CS Memorandum No. 1371

To: Distribution
From: Beverly Ward, CMB/Risk Management Assistant 
Date: March 5, 2013
Reference: Project No. M544.1, Contract No. CS-149
Task No. 1-8.02, Change Control
Subject: Configuration Management Board Meeting No. 114

CMB Meeting Minutes #114

SUBJECT: Configuration Management Board Meeting # 114 – Rev. No. 0

Drawing Nos. ES-305, ES-306 (see attached markup)

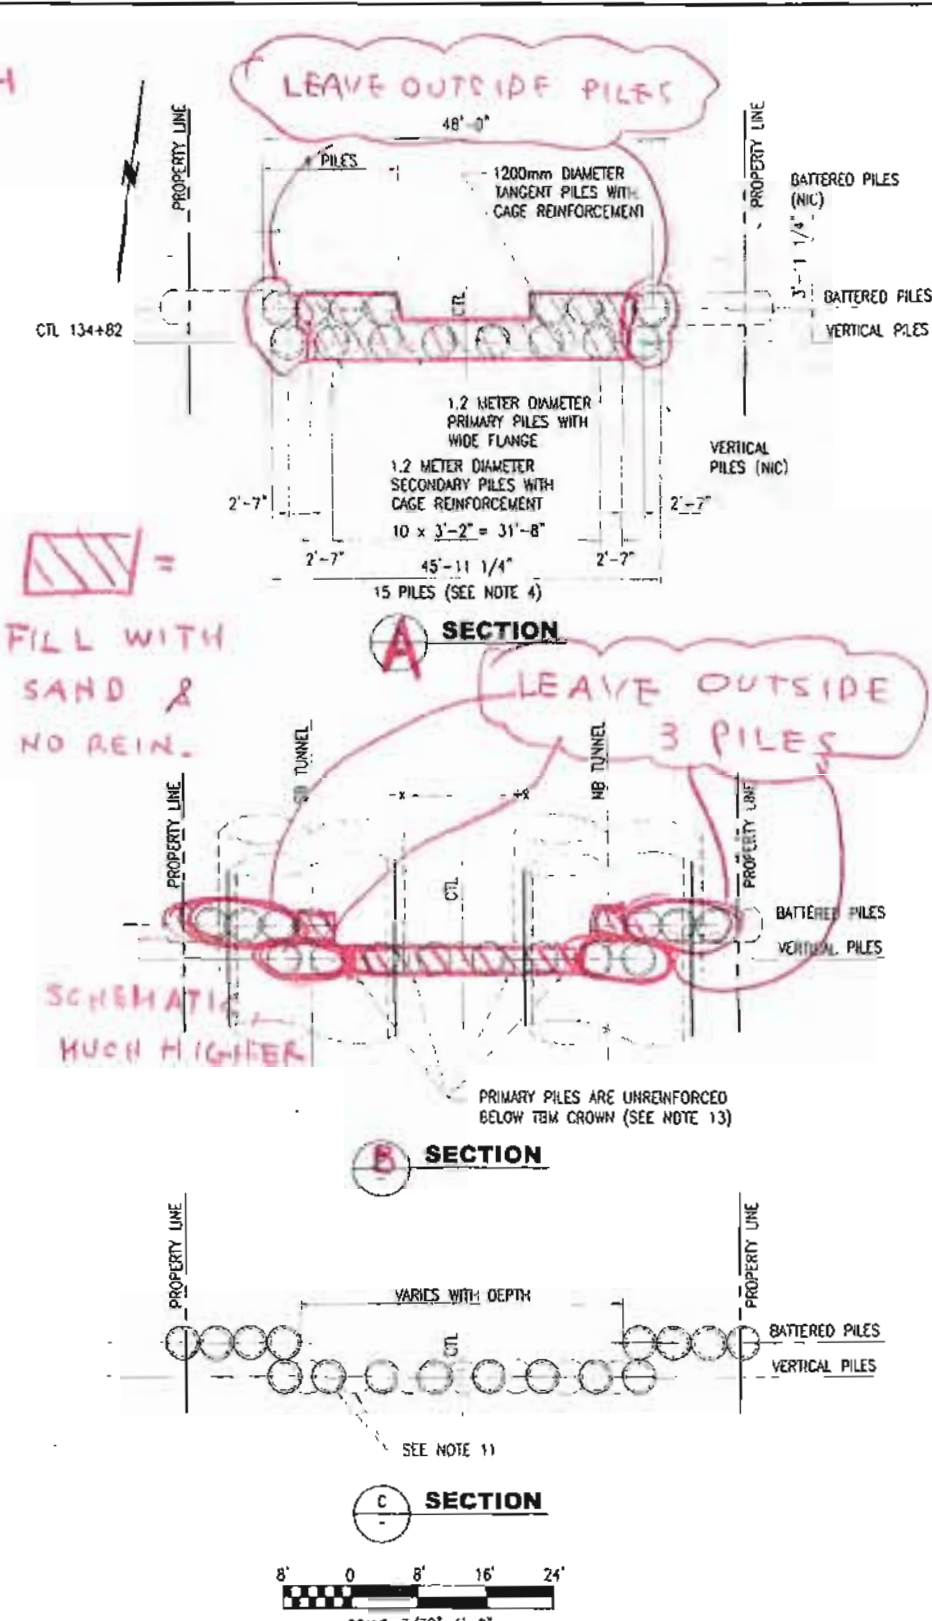
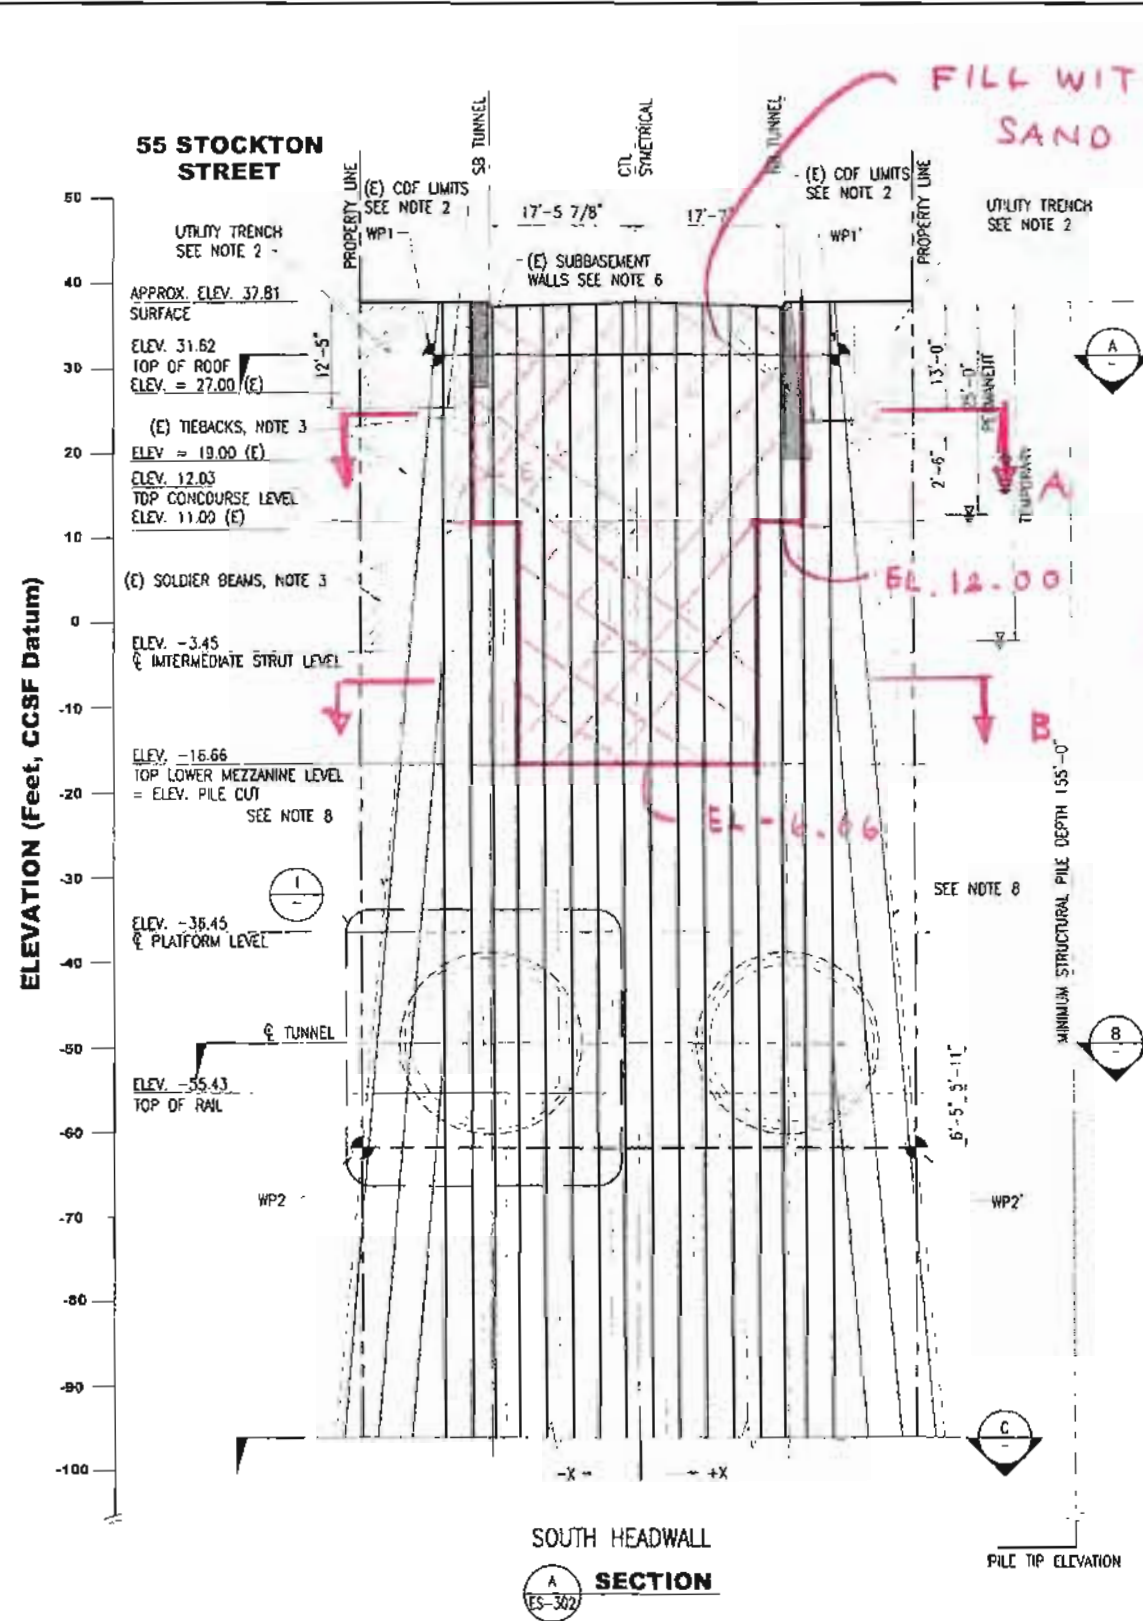
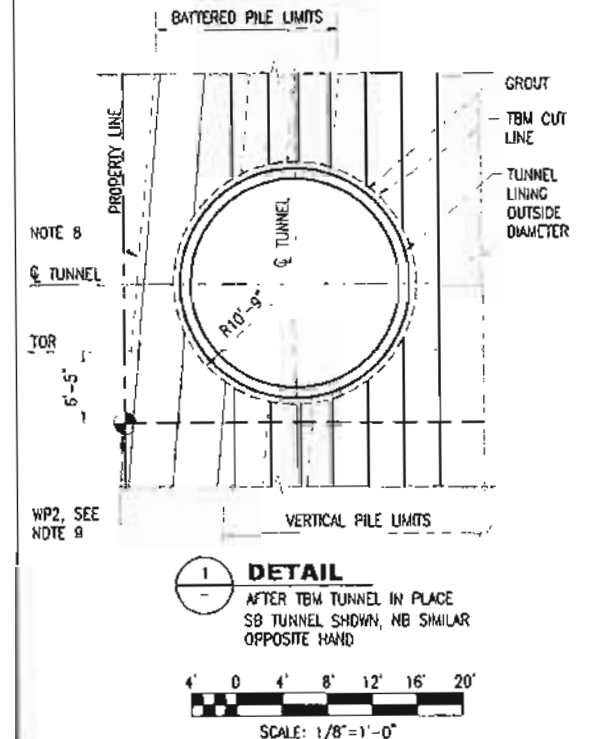
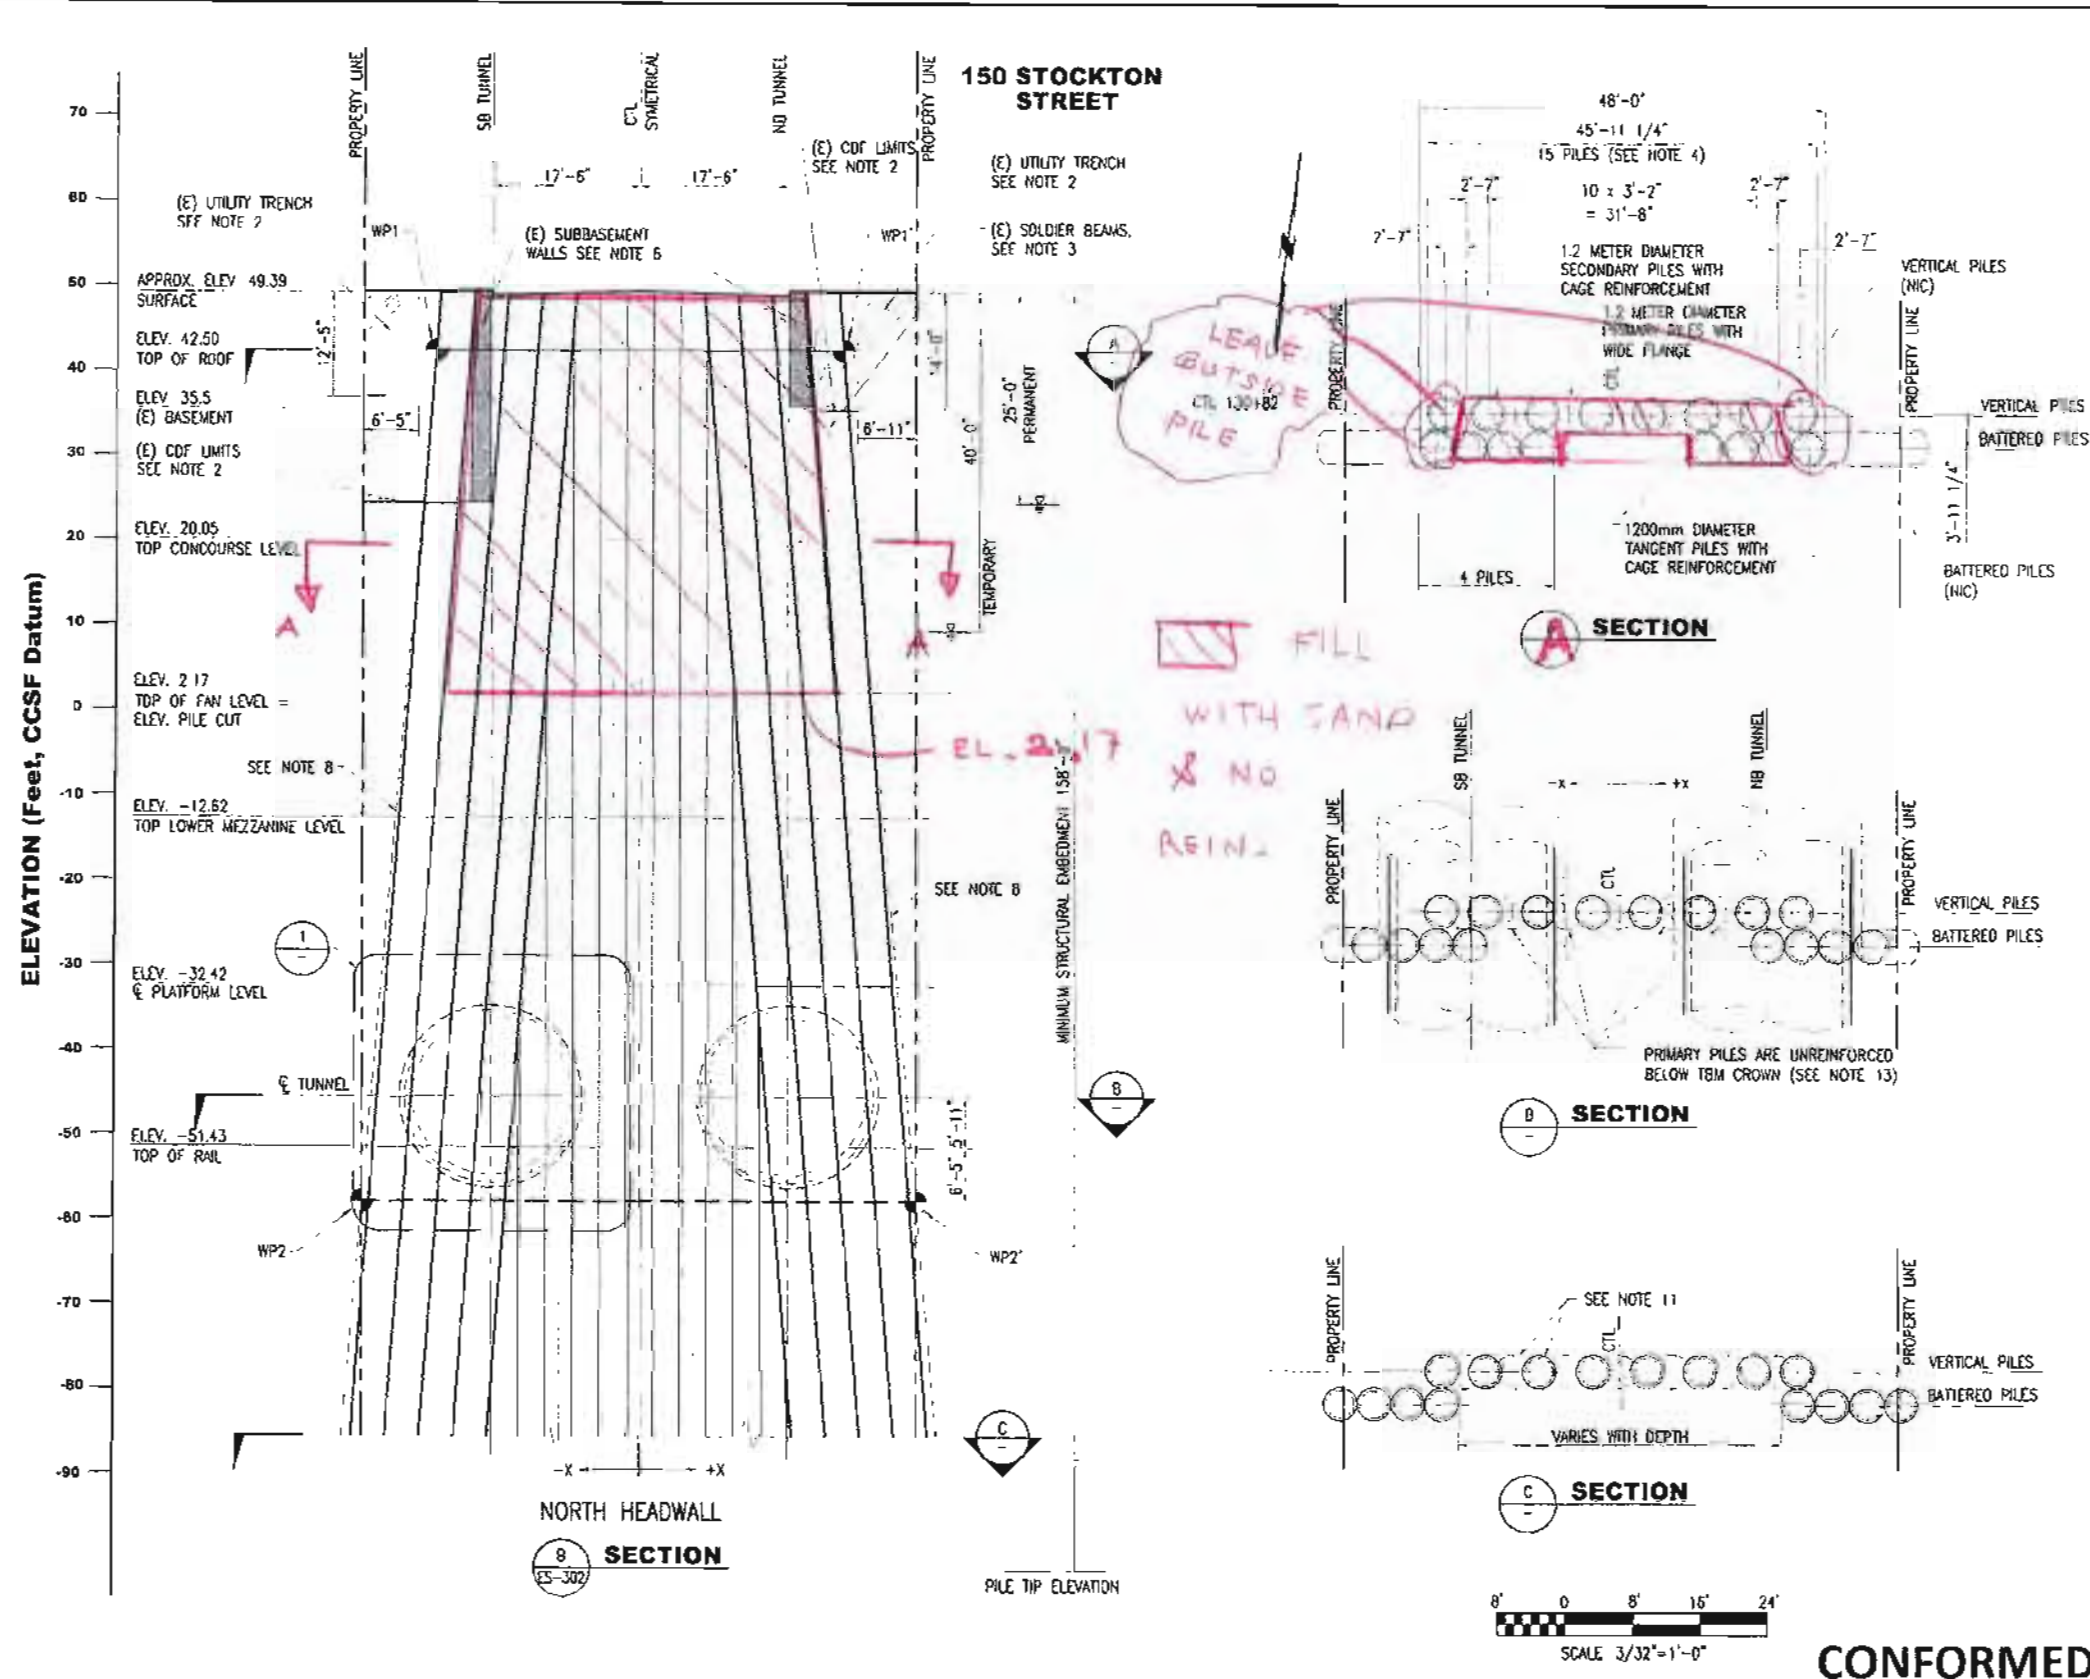
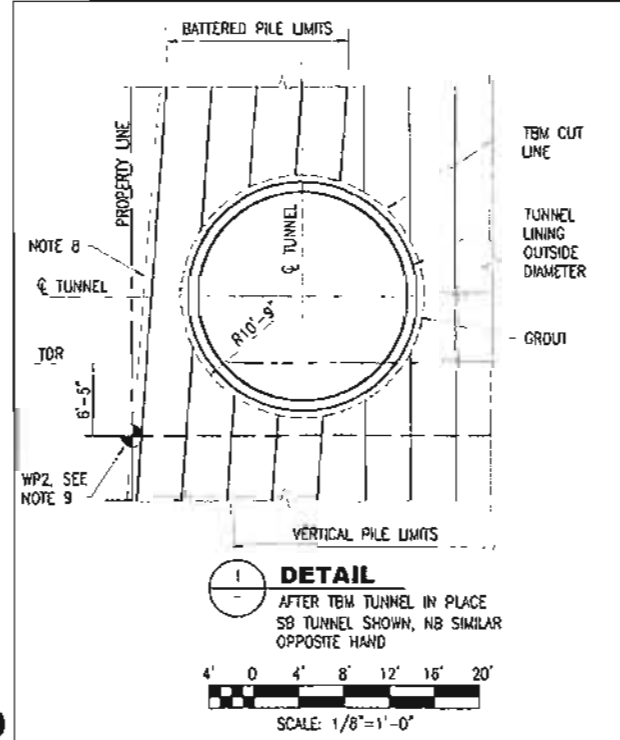
<p>1-</p>	<p>1251 - M. Benson presented for consideration Trend #37, 44 and 45 - Sewer Installation change for the Gucci Store, Macy’s West and Union Square Garage. Existing sewer laterals depicted on the contract drawings for the Gucci store and Union Square Garage were found to be connected to a downstream end of the existing main which required installation of new laterals. In additional the 8” sewer lateral for Macy’s West is too big to be connected directly to the 14” main requiring a new lateral be installed at a higher elevation (see photos attached). AGREE – CMB 0077. The CMB recommended that this issue be pursued as a potential E&O from the designer.</p>	
<p>2-</p>	<p>R. Edwards presented for discussion a review of the draft matrix proposal for the potential bid depicting an A+B+C+ D and/or Combined Bid Contract Strategy for discussion. A meeting will be set up next week to present a draft mock-up the proposal CSP/SFMTA Program Management.</p>
